Bradley Heights Apartments

A 236-Unit Apartment Development Puyallup, Washington

Bradley Heights SS LLC

BUILDING B 3rd LEVEL PLAN
 1/8" = 1'-0" 3/4 SPLIT LEVEL, 14-UNIT BUILDING

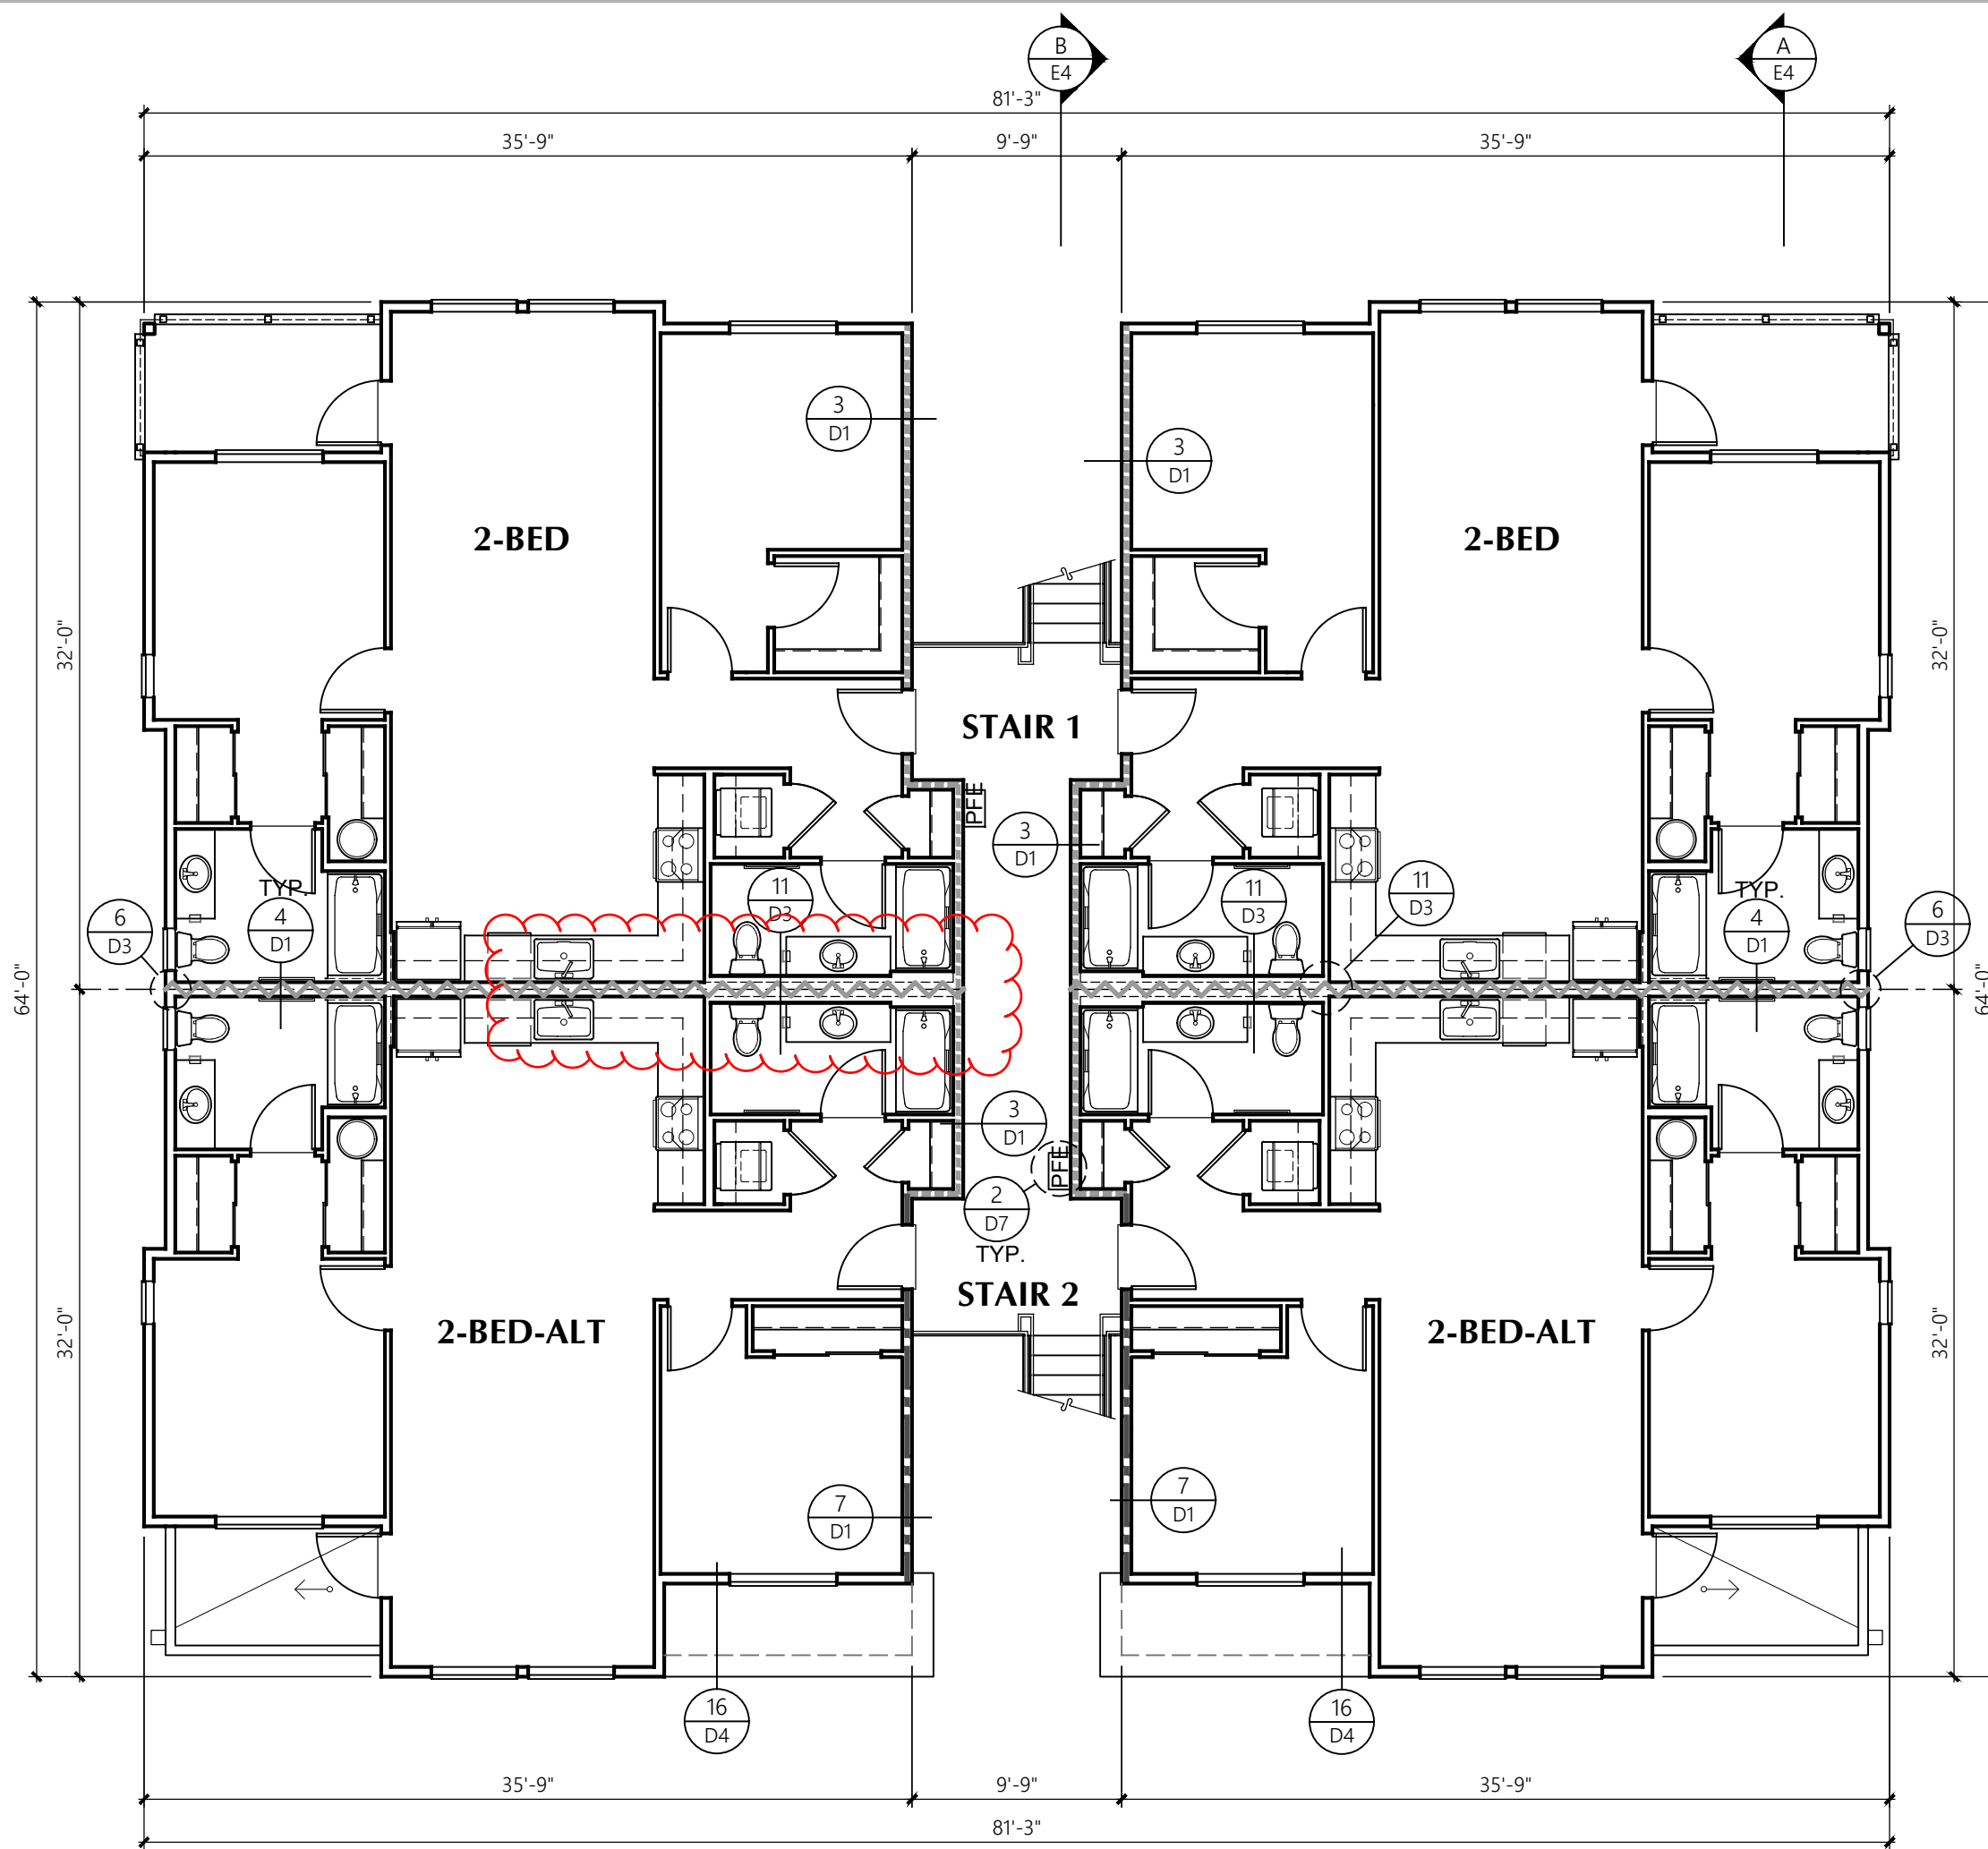
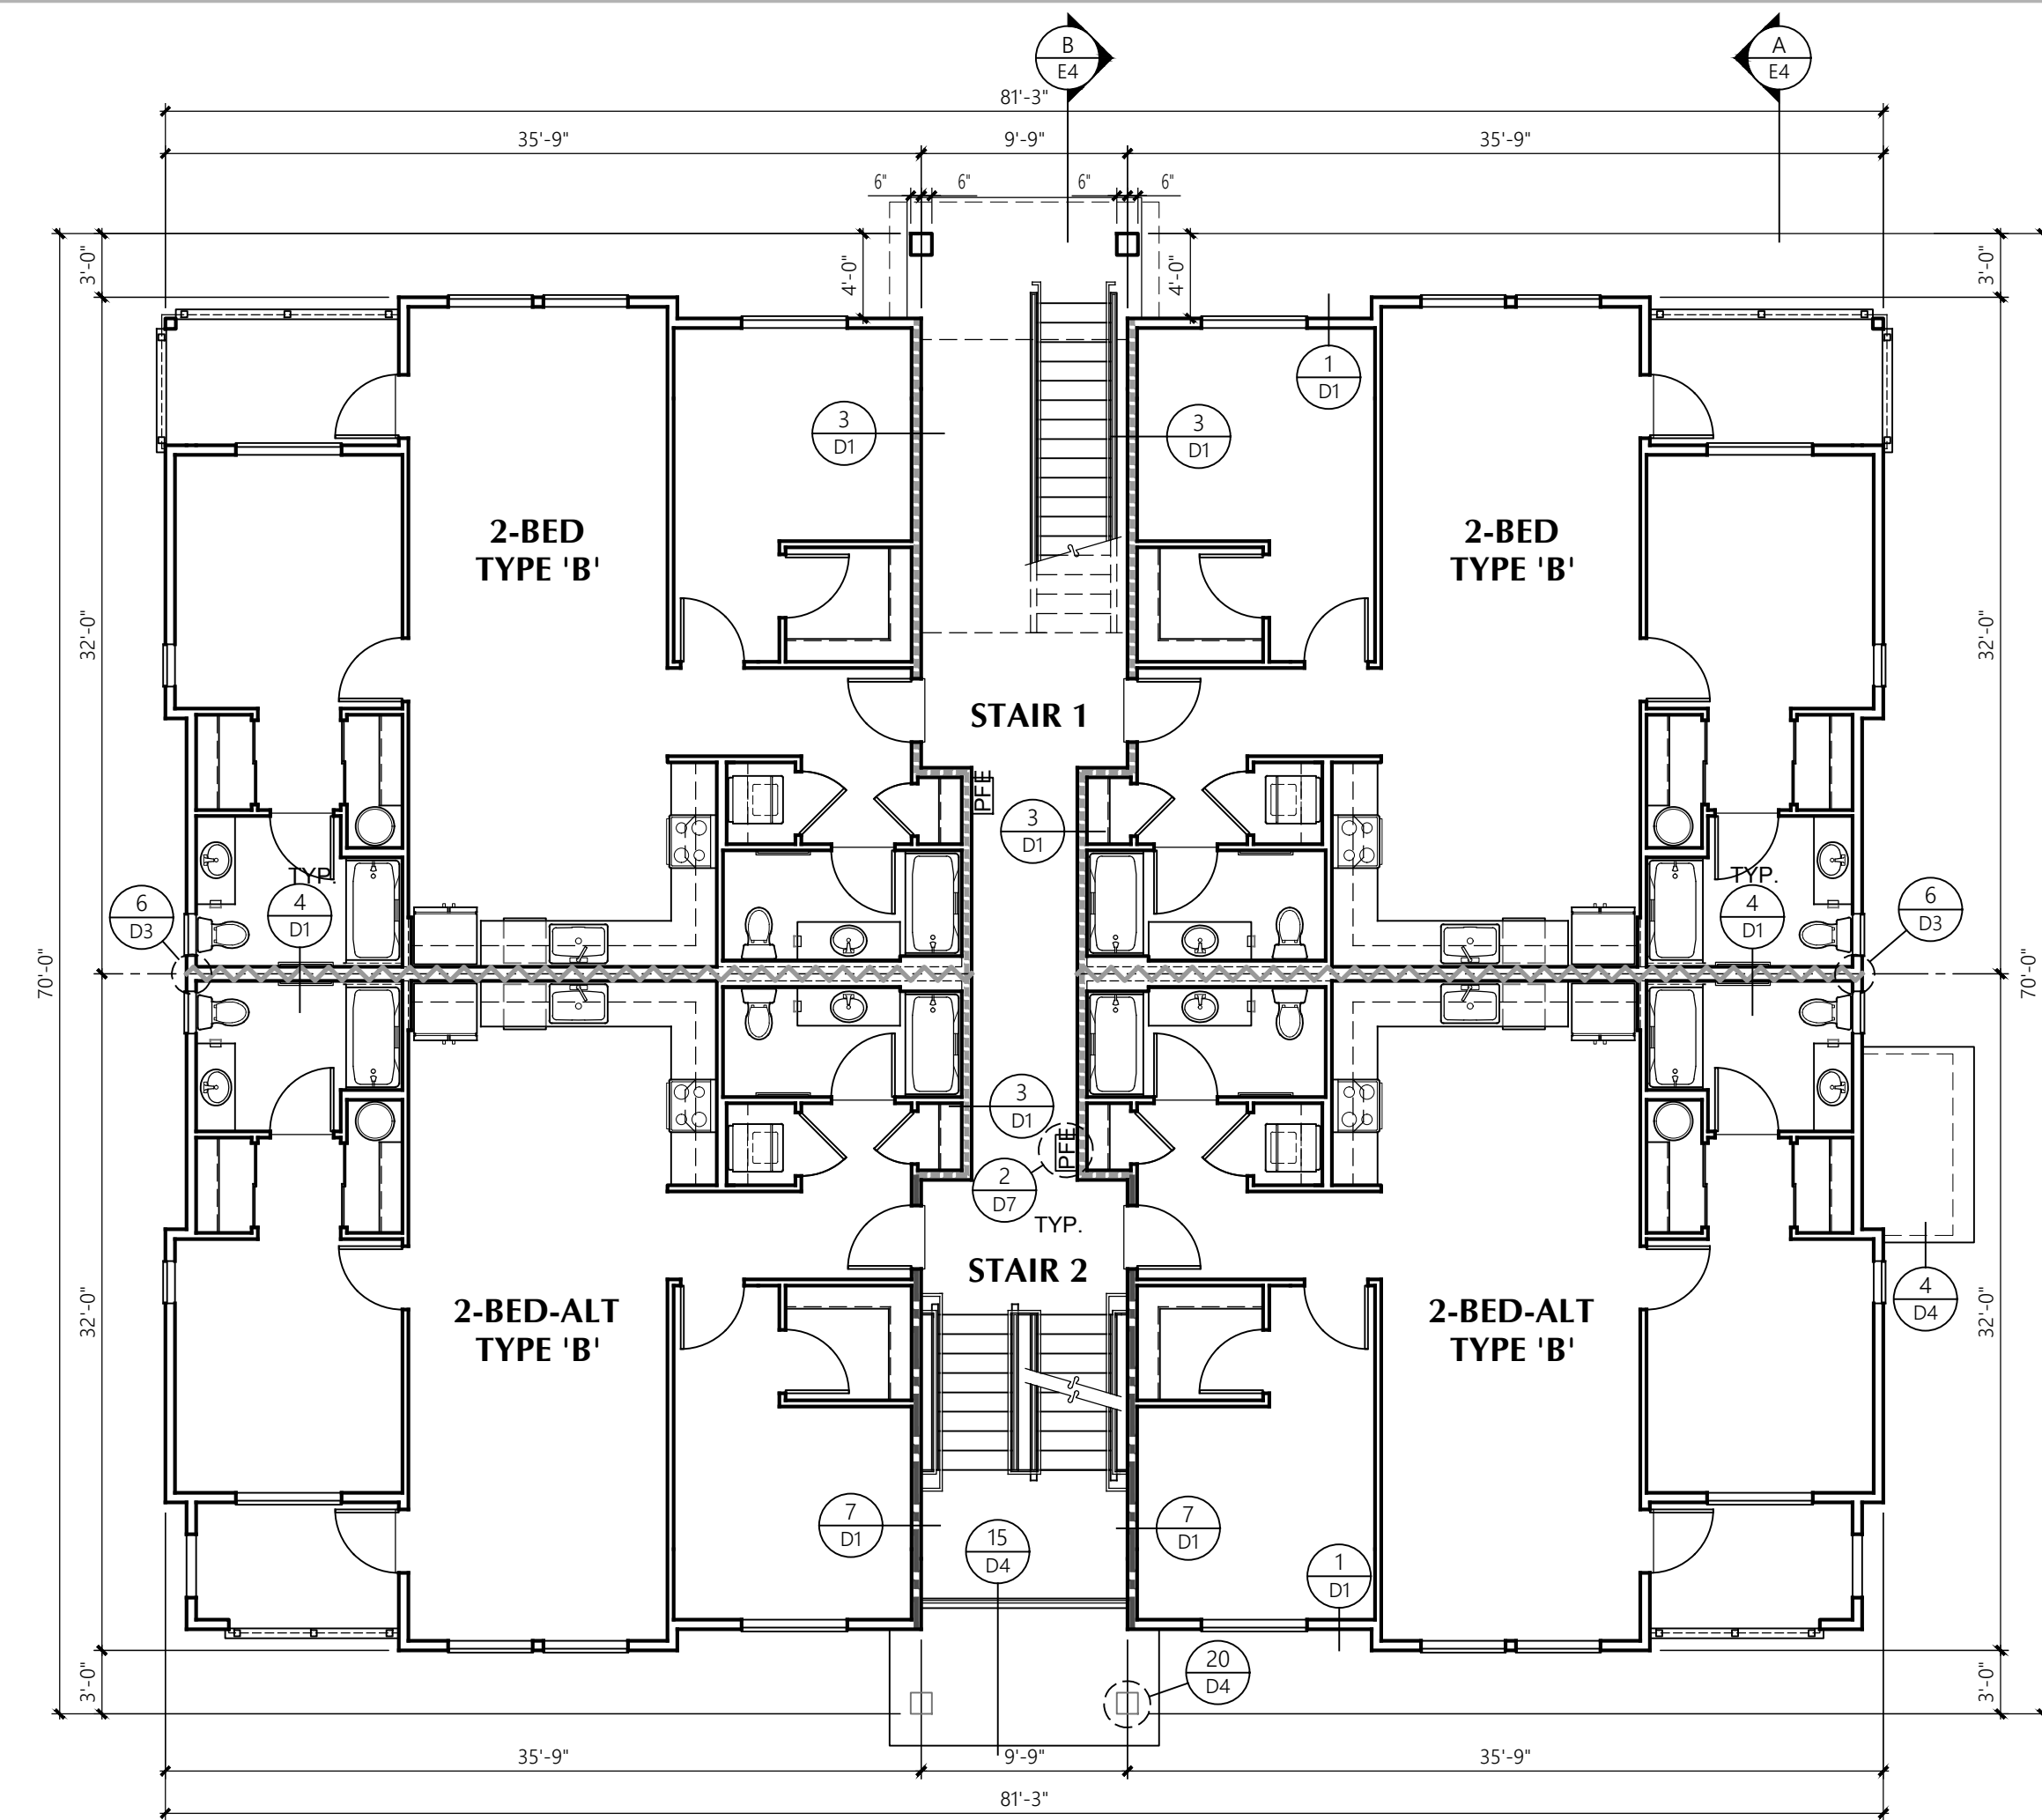
Provide fire stop detail for plumbing in 1-HR rated wall for all penetration in wall separating units.
 Wall section #6 unit separation wall does not reflect penetration in rated wall.
 Page B3
